Subject: AP1000 Response to Request for Open Item (SRP 3)

AP1000 TECHNICAL REPORT REVIEW

RAI Response Number: RAI-TR09-008

Question:

Figure 6.2.1.1-11 AP1000 External Pressure Analysis Containment Pressure vs. Time

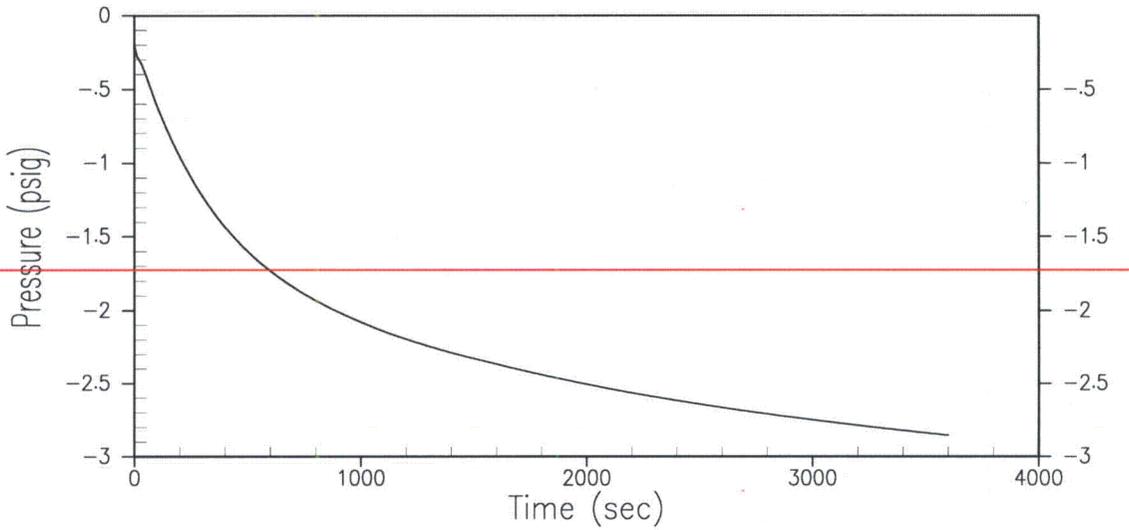
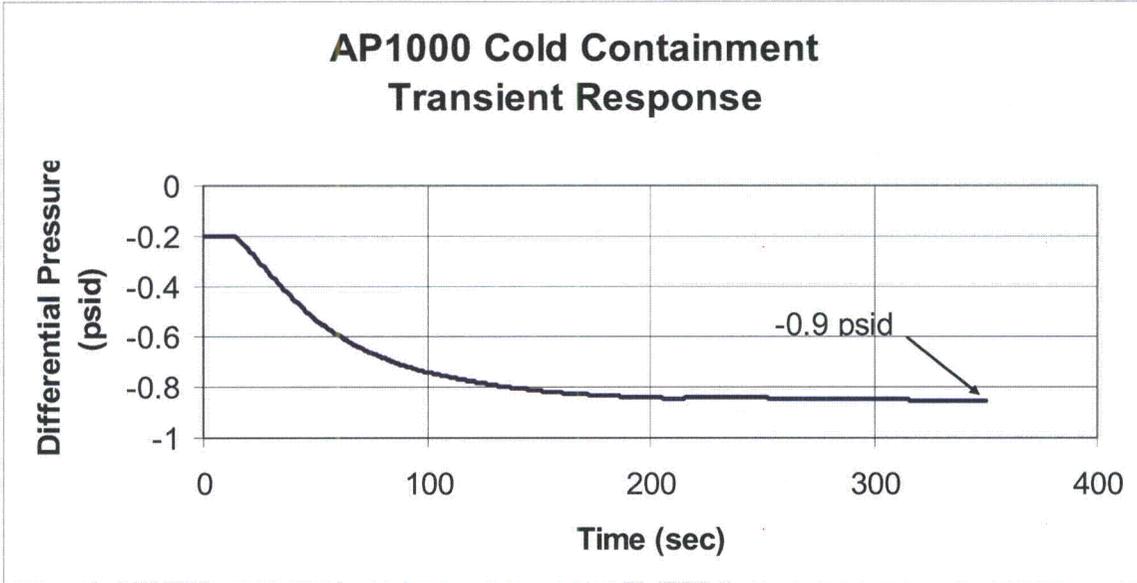
The following revisions to Subsection 6.2.1.1.4 and Figure 6.2.1.1-11 were provided in Revision 2 of this response. Please see the response to RAI-SRP6.2.1.1-SPCV-07 Revision 1 and 2 for more recent revisions to this subsection. RAI-SRP6.2.1.1-SPCV-07 Revision 2 modifies Subsection 6.2.1.1.4 to be similar to the description in DCD Revision 15.

For consistency with Figure 6.2.1.1-11, the words 'at one hour' were deleted from the text in section 6.2.1.1.4 of the DCD, Revision 16. This change and all other DCD changes shown below were incorporated in Revision 5 of APP-GW-GLR-134 (Technical Report 134).

Certain design basis events and credible inadvertent systems actuation have the potential to result in containment external pressure loads. Evaluations of these events show that an inadvertent actuation of active containment cooling ~~a loss of all ac power sources~~ during extreme cold ambient conditions has the potential for creating the worst-case external pressure load on the containment vessel. This event leads to a ~~reduction in the internal containment heat loads from the reactor coolant system and other active components, thus resulting in a~~ temperature reduction within the containment and an accompanying pressure reduction. Evaluations are performed to determine the maximum external pressure to which the containment may be subjected during a postulated actuation of the active containment cooling ~~loss of all ac power sources~~.

The evaluations are performed with the assumption of a -40°F ambient temperature with a steady 48 mph wind blowing to maximize cooling of the containment vessel. With no active cooling in use ~~the~~ initial internal containment temperature is conservatively calculated ~~assumed~~ to be 69 ~~120~~°F, creating the largest possible temperature differential to maximize the heat removal rate through the containment vessel wall. A negative 0.2 psig initial containment pressure is used for this evaluation. A conservative maximum initial containment relative humidity of 100 percent is used to produce the greatest reduction in containment pressure due to the loss of steam partial pressure by condensation. It is also conservatively assumed that no air leakage occurs into the containment during the transient.
